HFC / POE COMPRESSOR MODIFICATIONS

06E Semi-Hermetic Compressor

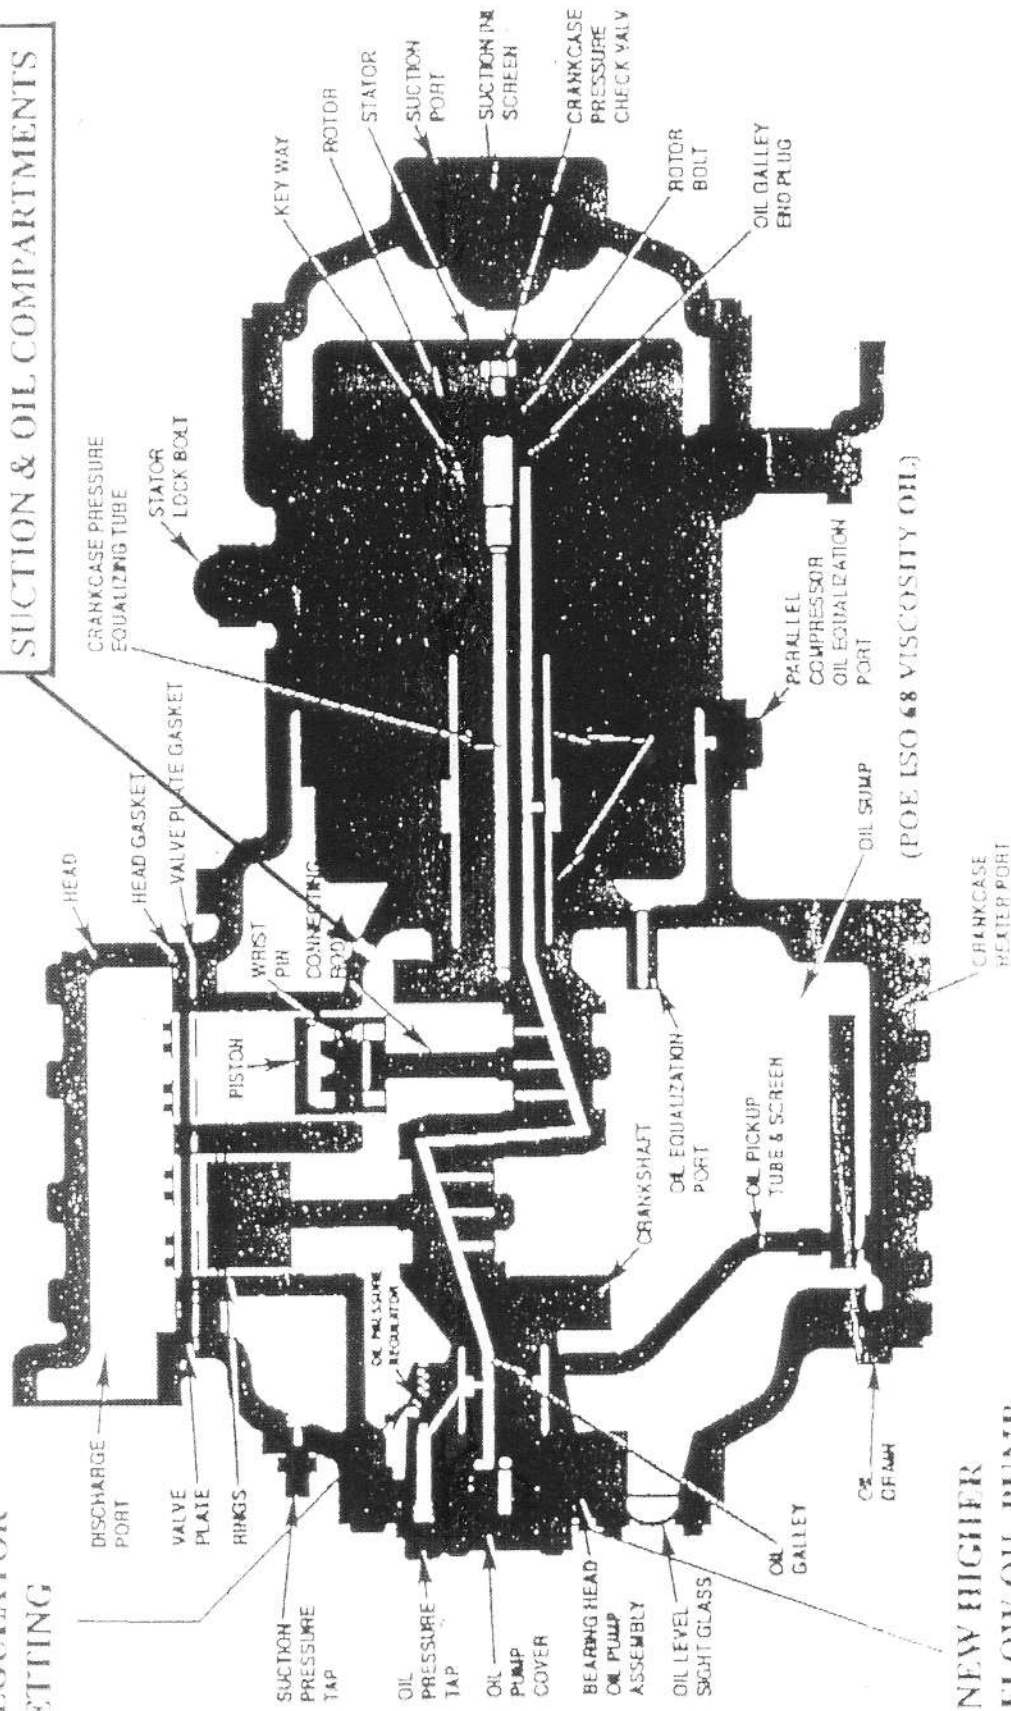
VENT HOLE DIAMETER 1/4".
ADD VENT BETWEEN
SUCTION & OIL COMPARTMENTS

NEW
REGULATOR
SETTING

NEW HIGHER
FLOW OIL PUMP
